SUBJECT: Forwards licensee response to NRC 881213 questions on util long term seismic program final rept.

Re: Docket No. 50-275, OL-DPR-80
Docket No. 50-323, OL-DPR-82
Diablo Canyon Units 1 and 2
Response to NRC Staff Questions on the
Long Term Seismic Program Final Report

**RESPONSE TO QUESTIONS 43n, 43z (Part 2)
and 46**

RESPONSE TO QUESTION 16

Figure Q43n-1

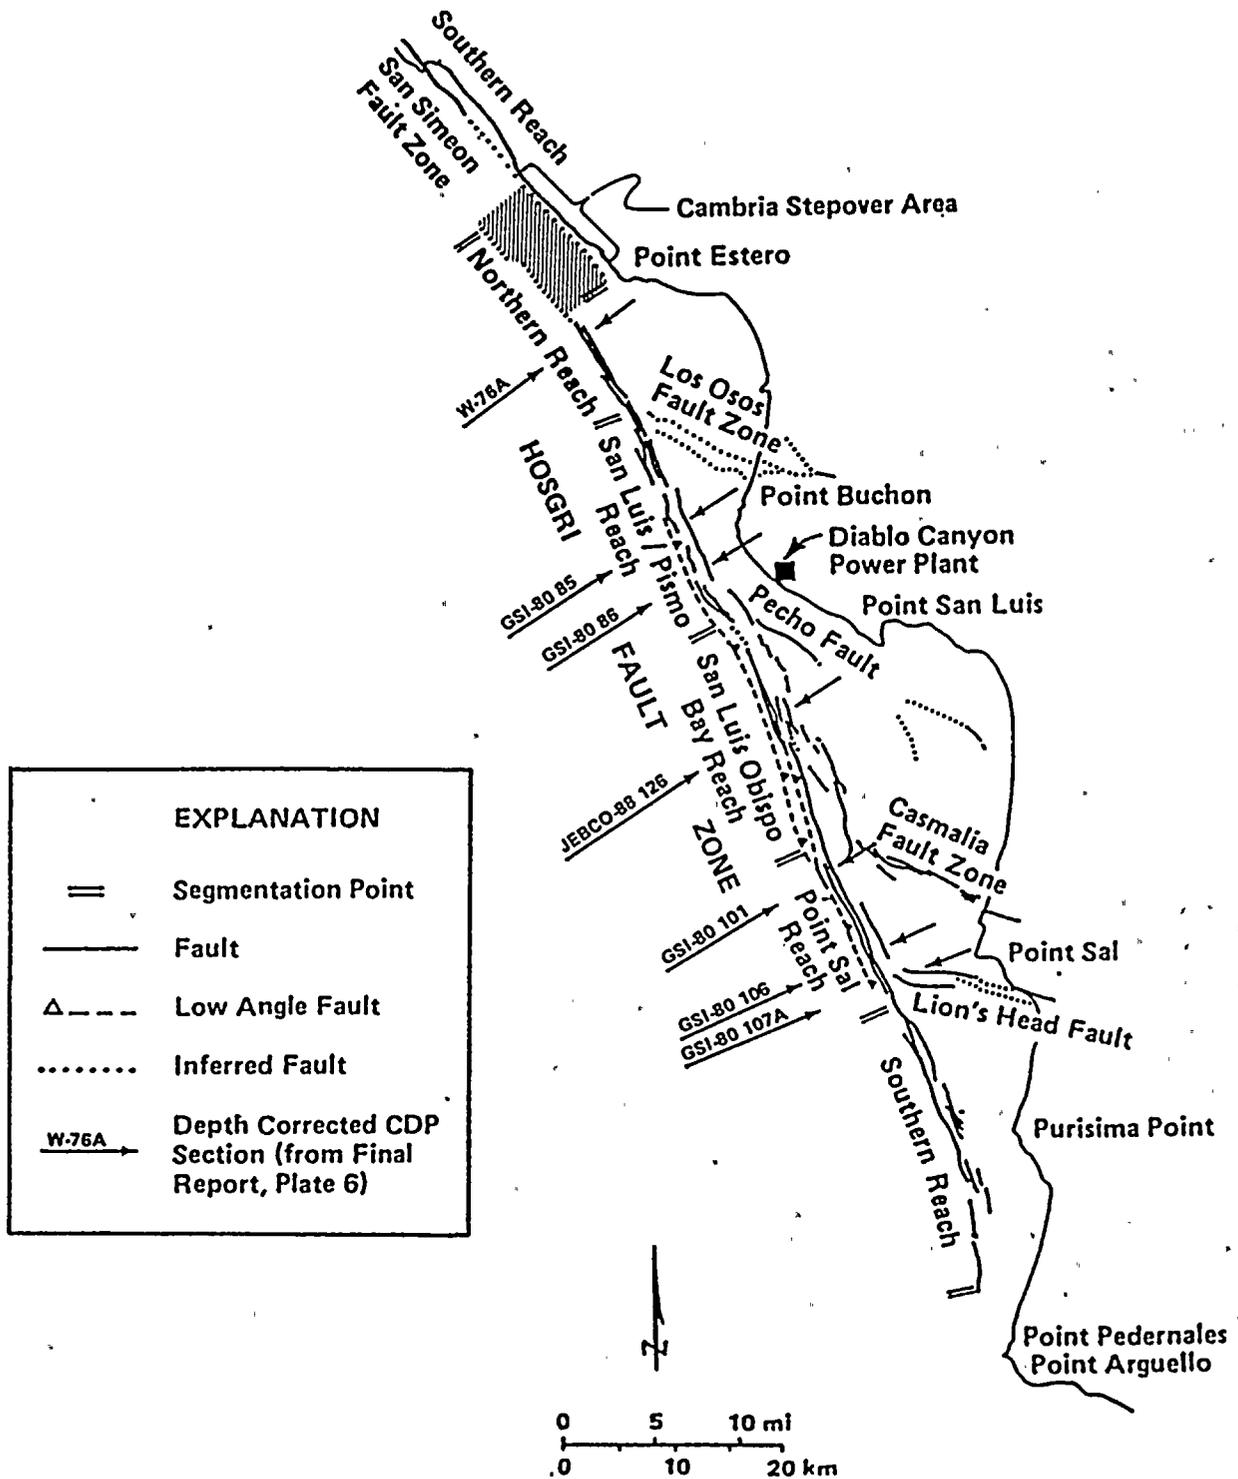
- n. The high resolution and CDP reflection profiles which show the style of deformation, continuity, and possible surface and subsurface position of segmentation points for the following:*
- (a) The Cambria step-over between the San Simeon and Hosgri faults.*
 - (b) Estero Bay-Los Osos zone of deformation east of the Hosgri fault.*
 - (c) Hosgri fault west of Pt. Buchon and Diablo Canyon.*
 - (d) Offshore SW border of the Pismo block including seismic lines across the San Luis Bay-Rattlesnake trace, Olson trace, and offshore escarpments.*
 - (e) Zone of intersection between the Hosgri and Pecho faults, including mid-points and gaps along the Pecho fault.*
 - (f) Intersection of the Casmalia fault and Hosgri faults.*
 - (g)* Intersection of the Lion's Head fault and the Hosgri fault zone.*
 - (h)* Southern termination of the Hosgri fault zone.*

South of 59-Meter Ridge, the San Luis/Pismo reach of the Hosgri fault zone strikes N25°W for 22 ± 1 kilometers (Plate Q43o-3, Sheet 6; Figure Q43n-1; and Final Report Table 2-13). Along this reach, the Hosgri fault zone forms the western boundary of the highly deformed San Luis/Pismo structural block (Attachment Q43-1, Section 13, Figures H-14 and H-34). The Hosgri fault zone is generally 2 kilometers wide in this reach and is composed of three structural elements: a western trace that is near-vertical to vertical in the upper 1 kilometer, and dips 65 to 70 degrees northeast at depths of 3 to 4 kilometers; an eastern trace that dips 70 to 80 degrees northeast; and a low angle fault that dips 40 to 50 degrees northeast (Final Report Plate 6; Plates Q43k-2 and -3; Attachment Q43-1, Section 3, Figures H-17 and H-23).

The 22-km-long portion of the Hosgri fault zone between the intersection of the Los Osos fault zone to the north and the Pecho fault to the south is referred to as the San Luis/Pismo reach (Figure Q43n-1). The characteristics of this reach are discussed in the Final Report on pages 2-101 to 2-103 and are summarized in Table 2-13 (page 2-121).

This segmentation point separates the Point Sal reach of the Hosgri fault zone to the north from the southern reach of the Hosgri fault zone (Figure Q43n-1; Plate Q43o-3, Sheet 3). The southern reach differs from other reaches of the Hosgri fault zone in that neither the western nor the eastern trace clearly marks the eastern limit of the offshore Santa Maria Basin (Attachment Q43-1, Section 7, Figures H-83 and H-84, and Section 8, Figure H-86). Rather, the fault traces lie within a section of raised and folded sediment of probable middle Tertiary age (compare Attachment Q43-1, Sections 6 and 13 with Sections 7, 8, and 14). In addition, the southern reach truncates several east-west-trending folds that bend to the south as they approach the eastern side of the Hosgri fault zone (Attachment Q43-2, Section 23; Plate Q43o-3, Sheet 3).

Figure 5. Fairfield Survey, Line SM-112

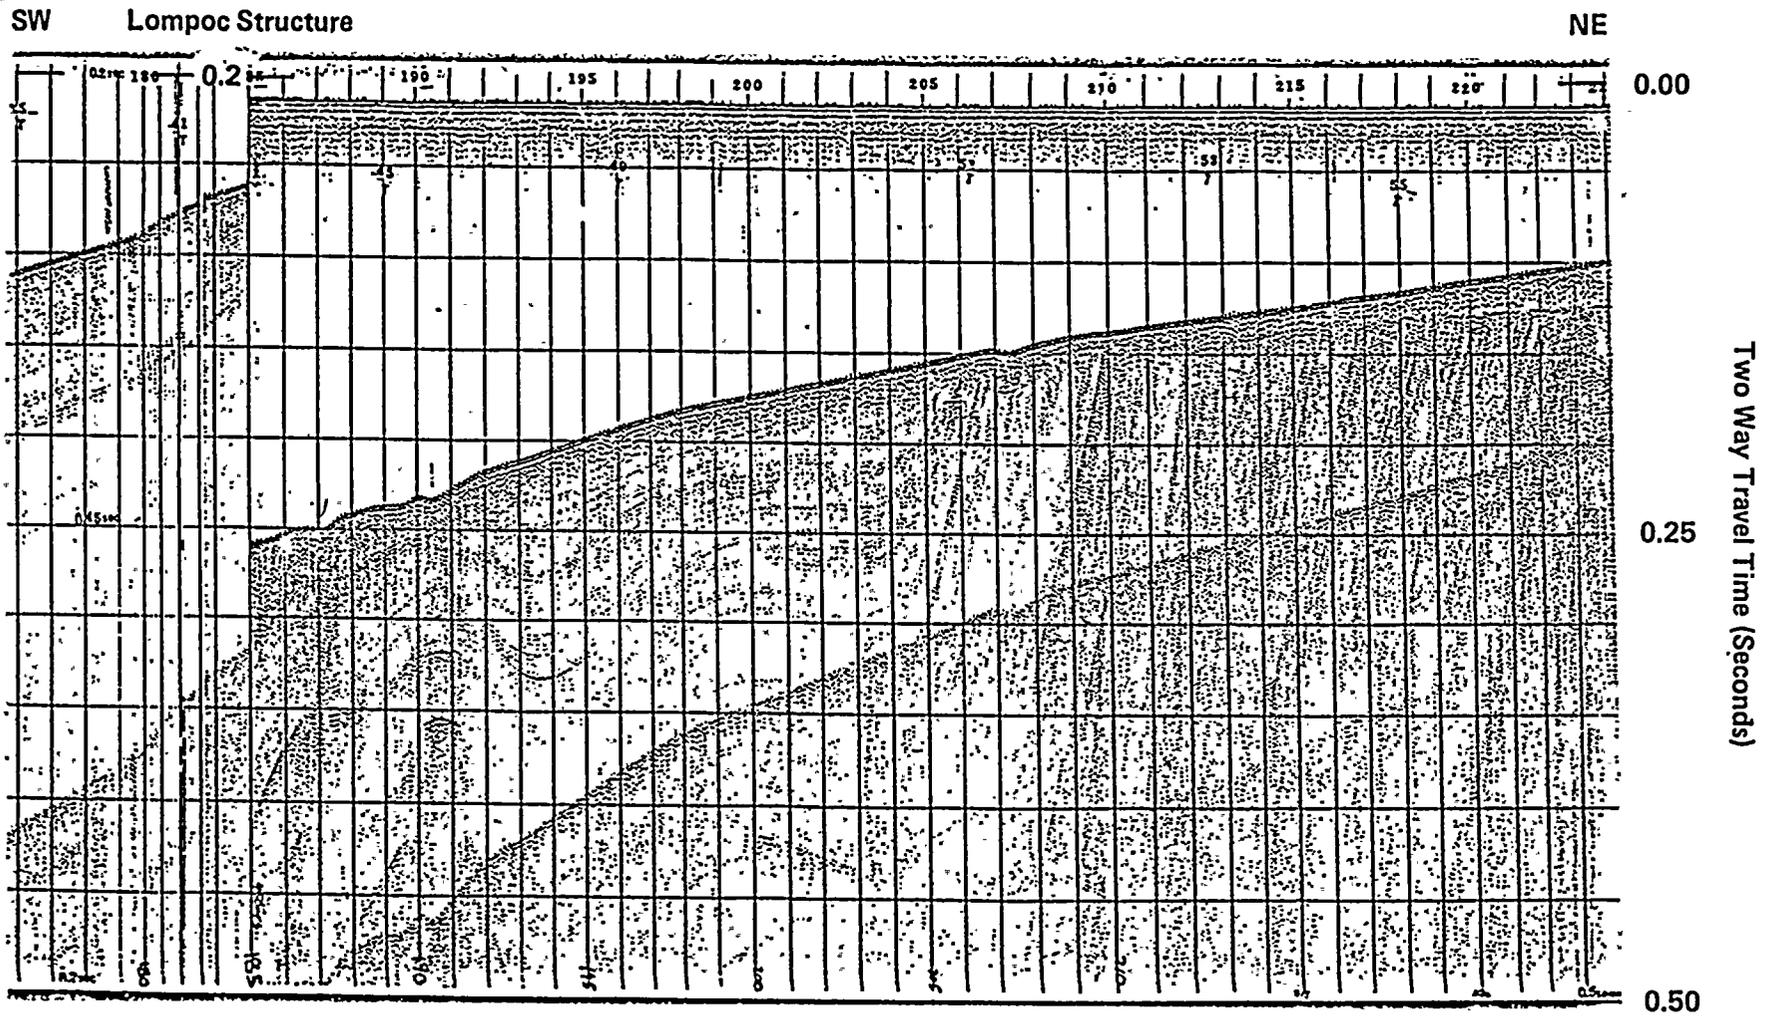
- z. Draft reports and seismic reflection data (including high resolution profiles) for the style, rates and timing of deformation on the section across the Queenie structure to the Pt. Sal area, and also for the Lompoc structure.*

Lower Pliocene units appear to lap onto the Lompoc structure and are partially folded. Fairfield line SM-112 (Figure 5, shot points 179 to 194) indicates that upper Pliocene units are also folded across the structure, although it is not clear whether Pleistocene deposits are disturbed. Figure 5 (shot points 194 to 203) and GSI-112C (shot points 550 to 630) show that post-Miocene sediments and the seafloor within the basin bounding the Lompoc structure to the east are slightly warped.

Figure Q46-1

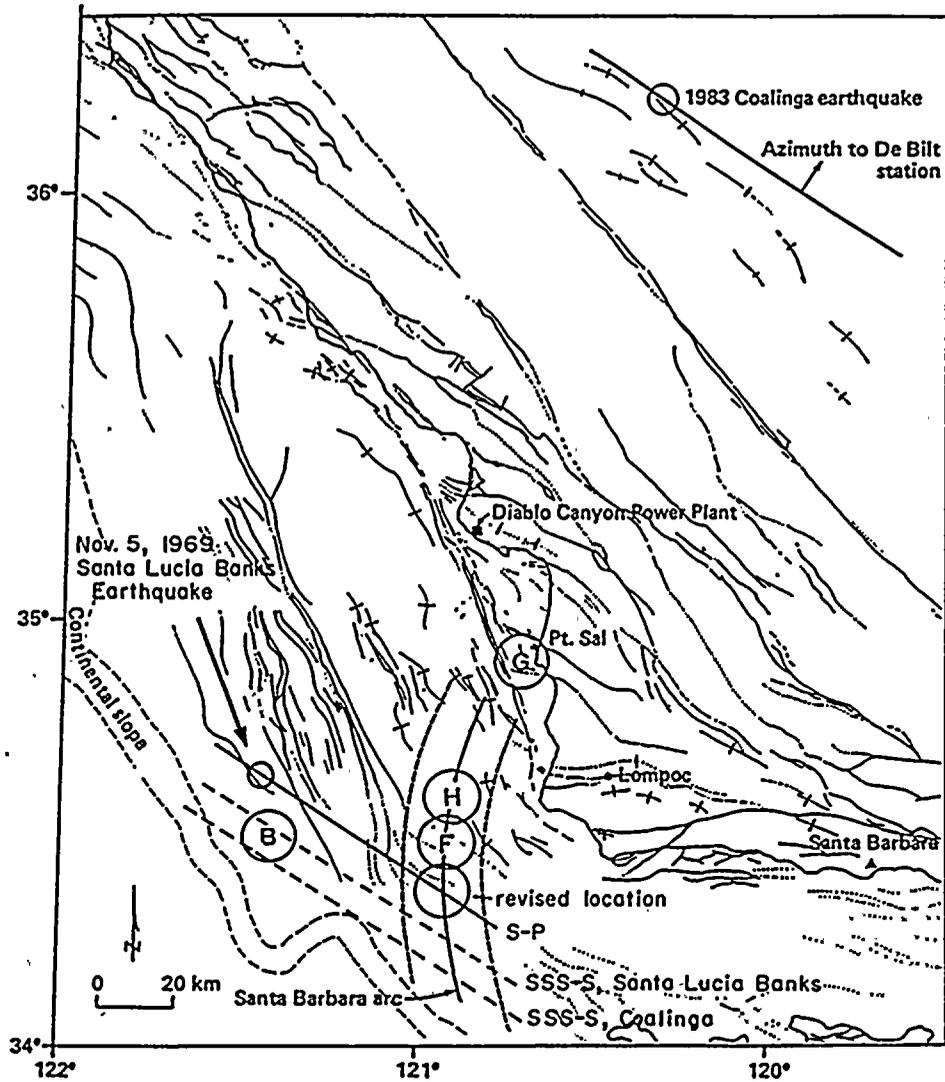
Confirming the method that was used to relocate the 1927 Lompoc earthquake by using it for other events in the region that have been located independently would provide confidence as to the accuracy of the relocation. Using the same technique as discussed in the text and shown in Figure 2-27, locate other earthquake.

We have used SSS-S and S-P time differences to estimate the location of the Lompoc earthquake with respect to the Santa Lucia Banks earthquake. The S-P interval that was used was measured from the onset time of P, which is clear for both events, to the first large peak of the S wave. We chose this peak rather than attempt to identify the S onset because the S waves are dominated by SV, so their onsets are contaminated by S to P conversions. The S-P times of the Lompoc and Santa Lucia Banks earthquakes are identical, as shown in Figure Q46-2. The location of the Lompoc earthquake with respect to the Santa Lucia Banks earthquake, according to this measurement, is on the small circle centered on DeBilt and drawn through the Santa Lucia Banks epicenter. The location of the Lompoc earthquake is established as the intersection of this arc with the Santa Barbara arc.

As before, we have used SSS-S times rather than SS-S times because the SSS phase is larger than the SS phase on the DeBilt seismograms, and does not have the phase-shift with respect to S that the SS phase contains. The difference in SSS-S interval between the Lompoc and Santa Lucia Banks earthquakes was measured by aligning the two S waves using cross-correlation, and then finding the time difference between the two SSS waves using cross-correlation, as shown in Figure Q46-3. The SSS-S time of the Lompoc event is 0.5 second greater than that of the Santa Lucia Banks event, placing the Lompoc earthquake about 12 kilometers south of the location derived from S-P data. The proximity of the Lompoc and Santa Lucia Banks earthquakes is reflected in the similarity of their waveforms; this is particularly evident when the Santa Lucia Banks record is lowpass filtered (Figure Q46-3) to provide a better comparison with the larger Lompoc earthquake. This provides further confirmation of the proximity of the two events.

Given the uncertainties discussed below, we conclude that the distance of the Lompoc earthquake from DeBilt is not significantly different from the distance of the Santa Lucia Banks earthquake from DeBilt. Together with the Santa Barbara arc, the DeBilt arc through the Santa Lucia Banks epicenter gives a revised location for the Lompoc Earthquake of 34.35°N , 120.9°W . This location is about 15 kilometers south of that given in the Final Report, but is well within the uncertainty of that estimate.

Figure Q16-1

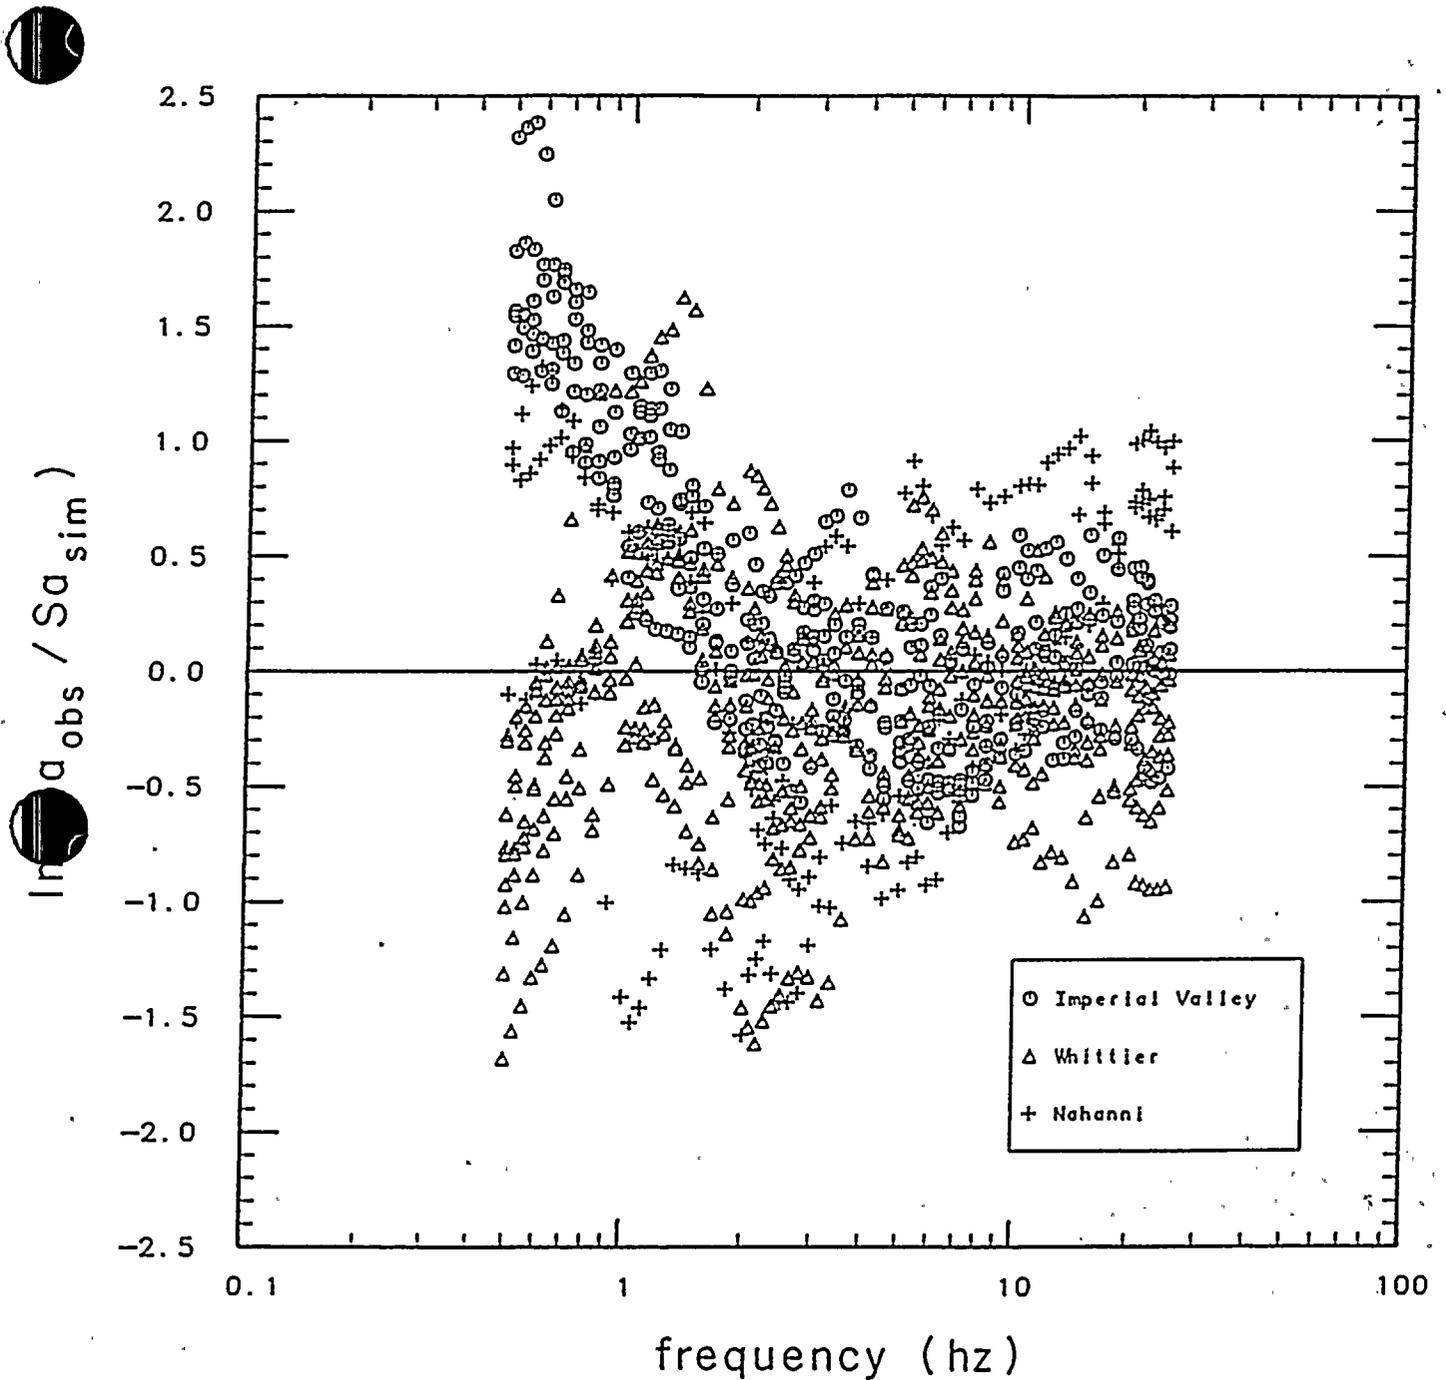
Provide a complete discussion as to how the 84th percentile numerical modeling estimates were made and how they address the various types of modeling, parametric, and random uncertainties. Determine the quantitative goodness of fit measures for the numerical modeling procedures based upon the comparison of the numerical simulations with actual data from the Imperial Valley, Coalinga, Nahanni, and Whittier Narrows earthquakes referenced in the LTSP Final Report.

Averaged over the frequency range of 3.0 to 8.5 Hz, the mean bias is -0.128; the standard error of a single observation is 0.34 on the natural logarithm of response spectral acceleration. The negative bias indicates that the simulation procedure is overpredicting the recorded frequency averaged spectral acceleration by about 14 percent.
